No. 2148
ATA Code 74-30

SUBJECT: IGNITION - REMOVAL OF GROUNDING TAB FROM IGNITION SWITCH

EFFECTIVITY: BEECHCRAFT 76 Duchess, serials ME-3 through ME-437.

Figure 1

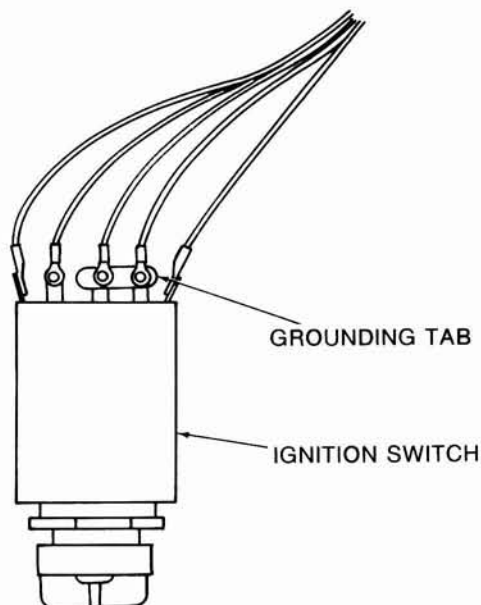
Tag the two wires which are connected by a grounding tab (see illustration). On the RH magneto, wire J4A22 connects to terminal "R" and wire J5A22 connects to terminal "L". On the LH magneto, wire J1A22

2. Refer to the illustration, remove the grounding tab and reattach the wires to the appropriate terminals.
3. Reinstall the ignition switch using the attaching hardware which was removed in Step 1.
4. Repeat this procedure on the opposite ignition switch.
